Date: 2/22/05

To: T10 Committee (SCSI)

From: George Penokie (IBM/Tivoli)

Subject: SAS 1.1 Signal Performance Measurements Annex

**Figure A.1 — A simple duplex link physical connection**

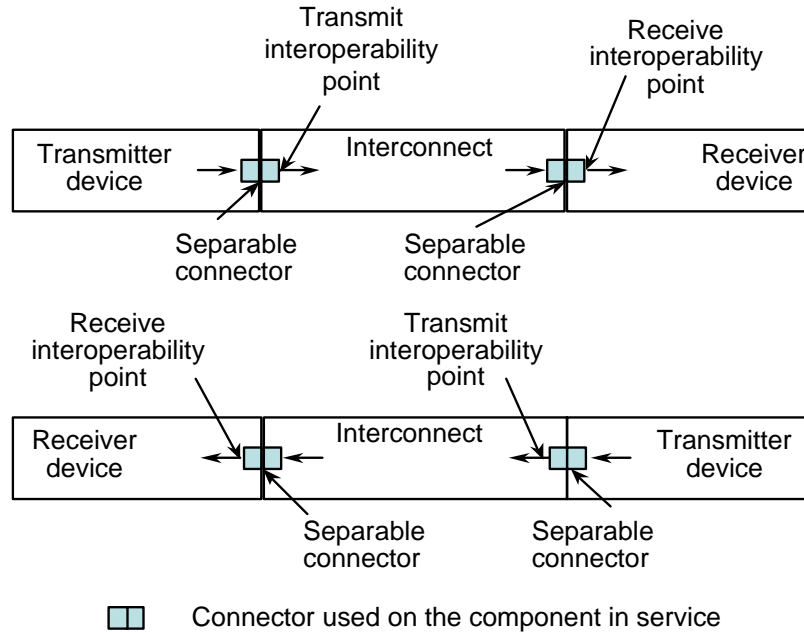
[Editor's Note 1: The last sentence does not make since and I don't know how to fix it.](#)

**Figure A.5 — Measurement conditions for transmitter device signal output specifications**

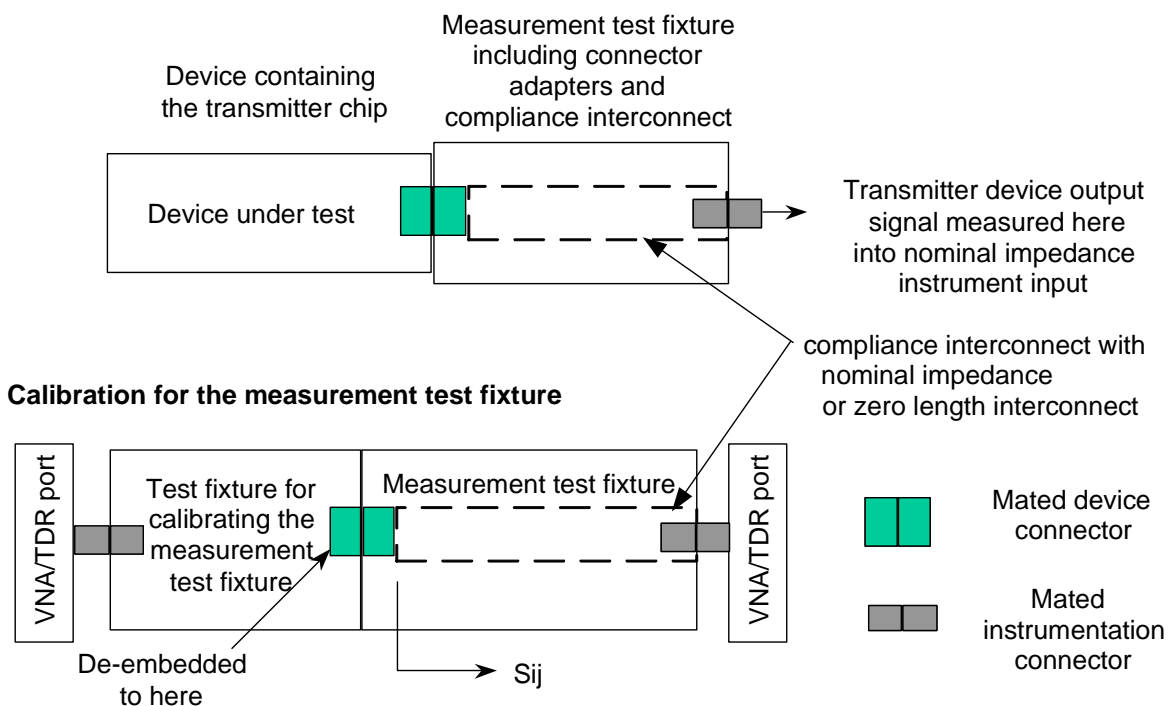
Editor's Note 4: The was a comment that the term "compliance interconnect" should be changed globally to "test load", "TCTF test load" or "zero-length test load". I don't know when which phrase is correct.

**Figure A.7 — Measurement conditions for system (interconnect + receiver device) signal tolerance**

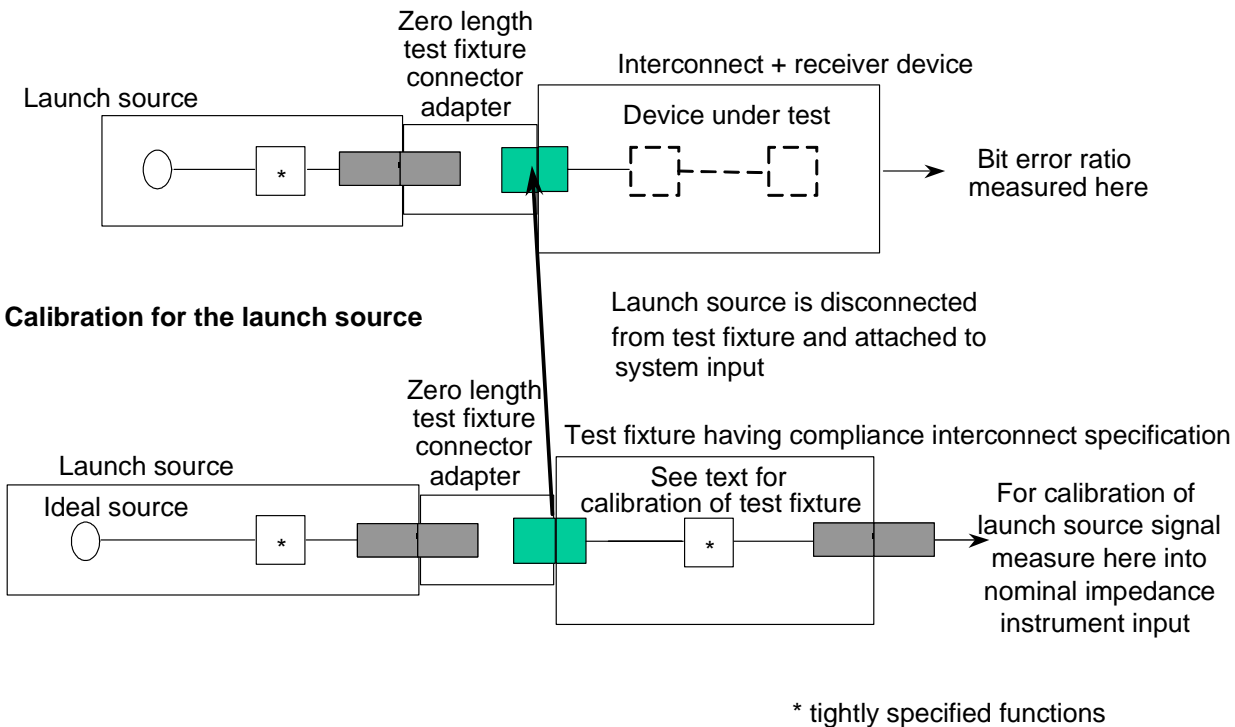
Editor's Note 5: SAS currently has no "signal tolerance at the transmitter device" specifications.

**Figure A.10 — Measurement conditions for signal tolerance at the receiver device**

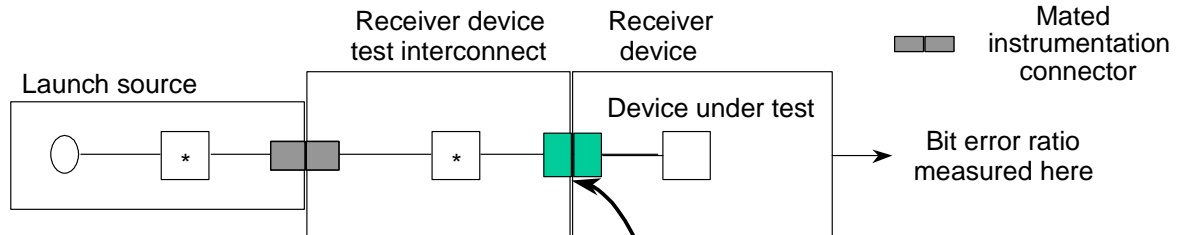
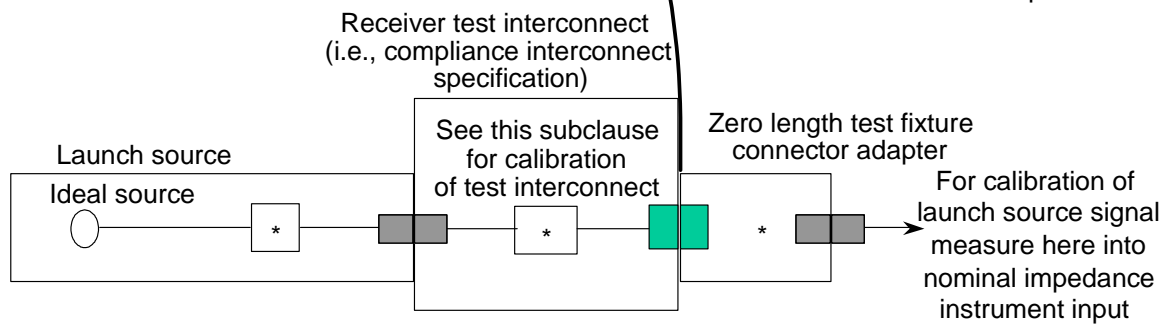
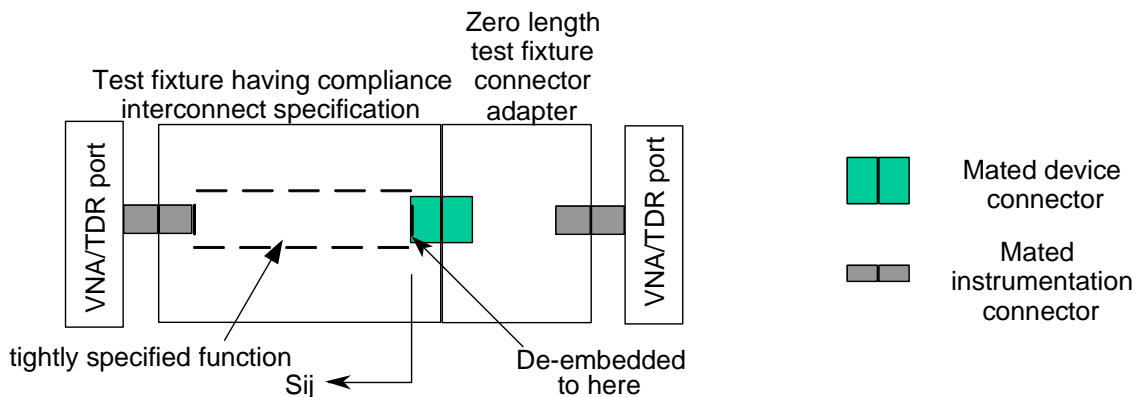
Editor's Note 6: The used of the term receiver device in items a and b above may not be correct.

**Figure A.13 — Four single-ended port or two differential port element**

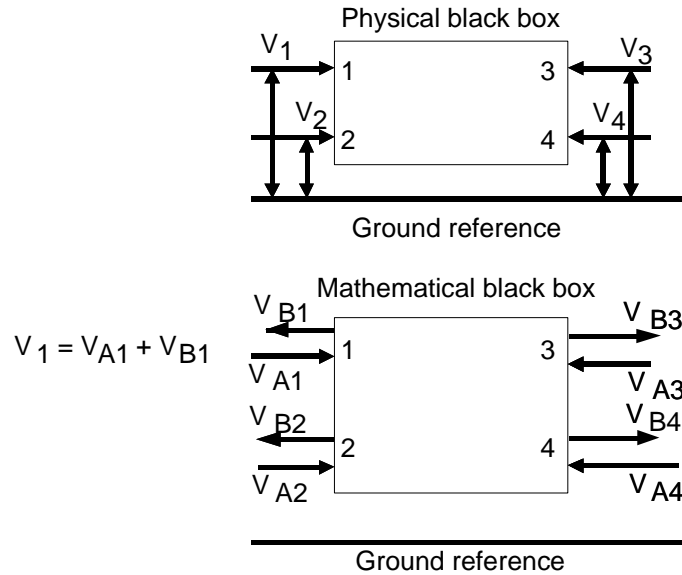
Editor's Note 9: In figure A.13 there appears to be missing arrows from the  $V_{xx}$  arrows to the ground reference in the Mathematical black box.
